CONTRACT NO:009540

CHANGE ORDER NO: 17

This Change Order adds Work to design and construct a Virtual Weigh in Motion (VWIM) system along SR 167.

WASHINGTON STATE  
 DEPARTMENT OF TRANSPORTATION  
 CHANGE ORDER

VWIM and Toll Site Layout

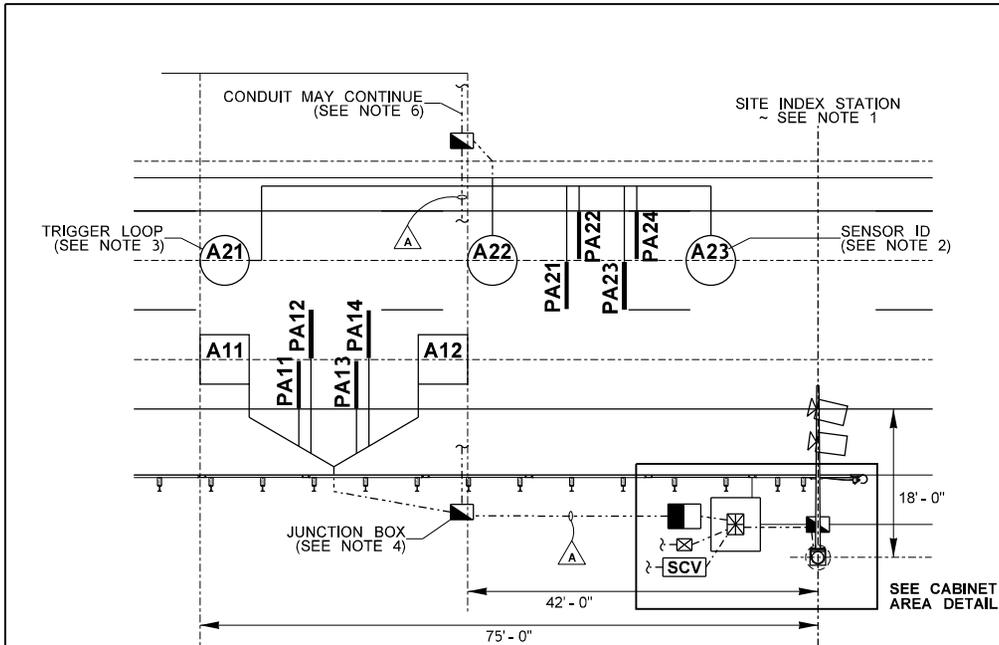
- The VWIM and Toll Site layout and spacing shall be consistent with the figure provided on page 18.
- VWIM cameras shall be located upstream and at least 100' from the southbound toll collection site.

- The revised Toll Gantry location shall not be placed further than 20 feet downstream of location (refer to page 18).
- As the design is developed for the VWIM and Tolling Sites there shall be coordination with the Toll Vendor with Tolling Task Force meetings.

Note: Maintenance pullouts, barrier, and cabinets locations have not been updated as part of this figure and shall be updated as part of final design.
